INDESIT company

Model type:
IDL40EU

Commercial code:
F030417

N1045072FIG1

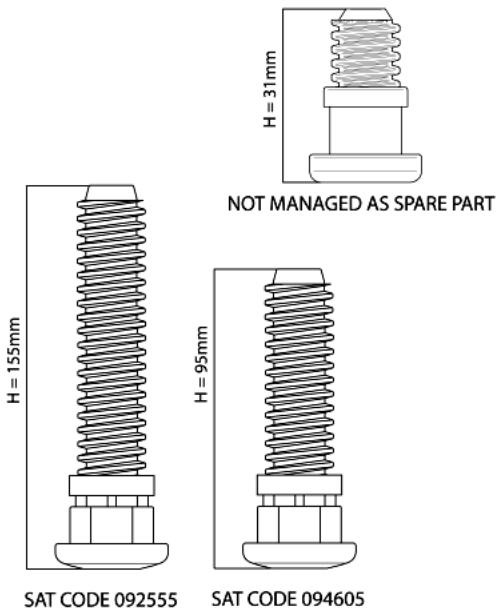
N1045072: Introduction of fixed rear foot H=31mm on free-standing models.

From serial no. 40218.0001, free-standing dishwashers affected by this modification have been equipped with new fixed rear feet (H=31mm).
The new foot replaces the adjustable one (H=155mm) Service code 092555; on the EVO3 range with TurboDry the new foot replaces the adjustable foot (H=95mm) Service code 094605.
The Spare Part Warehouse will continue to manage only 155mm and 95mm adjustable feet as they are interchangeable with the fixed 31mm foot.
The three feet are shown in illustration N1045072FIG1.

n1045085: Introduction of new litre counter turbine integrated on air-break.

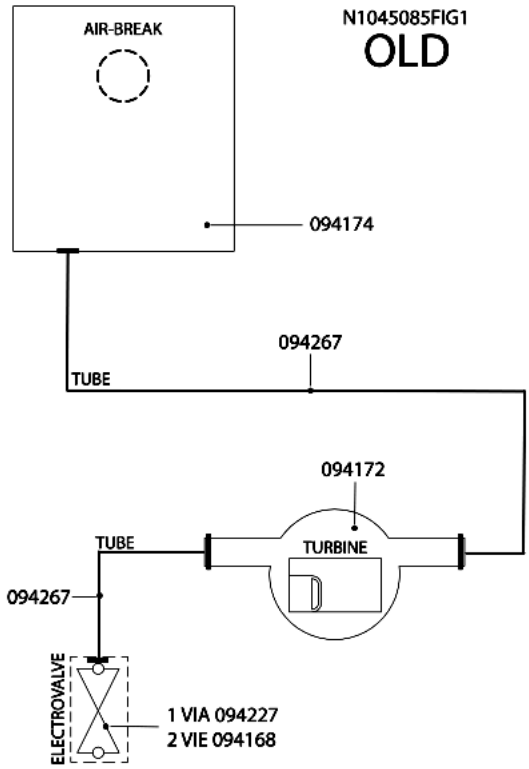
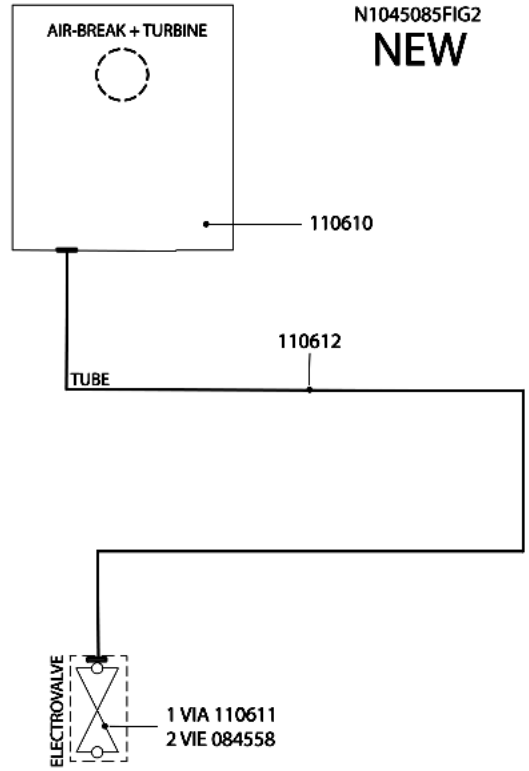
All dishwashers affected by this note have been equipped with a new litre counter turbine on the air-break.
Picture N1045085FIG1 illustrates the premodification structure, picture N1045085FIG2 the new structure.

Items affected by the modification.

AIR-BREAK:
new 110610;
premodification 094174;
the new item features a new integrated litre counter turbine and its water supply hose has a smaller diameter.

LITRE COUNTER TURBINE code 094172 has been eliminated.

SOLENOID VALVES:
new:
1-WAY code 110611;
2-WAY code 084558(Rohs 143737);
premodification:
1-WAY code 094227;
2-WAY code 094168;
the new solenoid valves have a smaller diameter drain hose fitting.

HOSES:
new solenoid valve hose/air-break code 110612;
premodification turbine hose/air-break code 094267;
premodification solenoid valve hose/air-break code 094267;
the new hose has a smaller internal diameter.

WIRING:
the litre counter turbine connecting cable is longer, but since the connector is the same, the new item can be used in place of the premodification one.
